Access Compliance Report

Public Rights-of-Way

(Curb Ramps)

Intersection ID: 30033	Main Street: DILLARD_RIDGE_DR	Cross Street: SOUTHWIND_DR	Location: E
ADA ID: 08C11A3A70C6	Ramp Type: Combination1Diag	Initial Pass/Fail: Fail	Overall Compliance: No
		Severity Score: 0

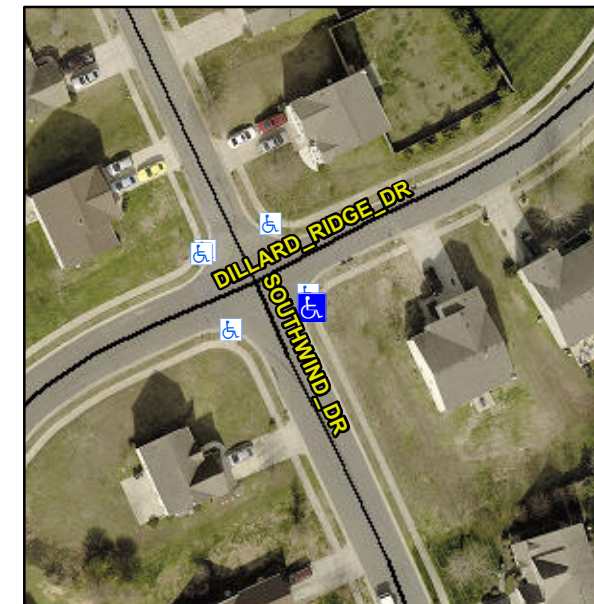
R304.5.1, R304.2.2, R304.5.3, R304.3.2

Compliance	Description	Data	Compliance	Description	Data
N/A	Ramp Length LT (in)	57.0	N/A	Ramp Length RT (in)	71.0
Yes	Ramp Width LT (in)	48.0	Yes	Ramp Width RT (in)	48.0
No	Ramp Slope LT (%)	16.6	No	Ramp Slope RT (%)	11.5
No	Ramp XSlope LT (%)	4.0	Yes	Ramp XSlope RT (%)	1.8
N/A	Ramp Length (in)	50.0	No	Ramp Slope (%)	17.0
No	Ramp Width (in)	39.0	No	Ramp XSlope (%)	10.2
N/A	Flare Type LT	N/A	N/A	Flare Type RT	N/A
N/A	Flare Slope LT (%)	N/A	N/A	Flare Slope RT (%)	N/A
N/A	Flare Traversable LT?	N/A	N/A	Flare Traversable RT?	N/A
N/A	Landing Length (in)	N/A	N/A	DWS Provided?	N/A
N/A	Landing Width (in)	N/A	N/A	DWS Contrast?	N/A
N/A	Landing Slope (%)	N/A	N/A	DWS Length (in)	N/A
N/A	Landing X Slope (%)	N/A	N/A	DWS Full Width?	N/A
N/A	Landing Curb? (Y/N)	N/A	N/A	DWS Offset (in)	N/A
N/A	Shared Landing?	N/A			
N/A	Gutter Ponding?	N/A	N/A	Gutter Slope (%)	N/A
N/A	Gutter Lip Ht (in)	N/A	N/A	Gutter X Slope (%)	N/A
N/A	Painted X Walk1?	No	N/A	Painted X Walk2?	No

Remove & Replace Curb Ramp With Two New Directional Ramps or Equivalent.
